UNITED STATES PATENT AND TRADEMARK OFFICE

APPLICATION NO.	FILING DATE	FIRST NAMED INVENTOR	ATTORNEY DOCKET NO.	CONFIRMATION NO.
09/877,217	06/11/2001	Ikuya Tsurukawa	206470US-2	9559

Office Action Summary

DETAILED ACTION

Yamaguchi figure 1.

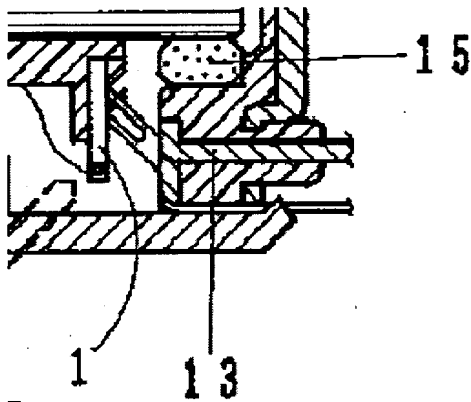
11. Applicant's arguments filed 3/7/2006 have been fully considered but they are not persuasive. Applicant's arguments regarding Yamaguchi are not persuasive because all the limitation are show by Yamaguchi as cited above. Particularly, the brush 11 with terminals 13 extending from the base 12 is shown in figure 2. The prior art of record

repeatedly shows the amended limitations: see CN 87 2 15879U as one of many examples (original IDS filed 10/9/03).
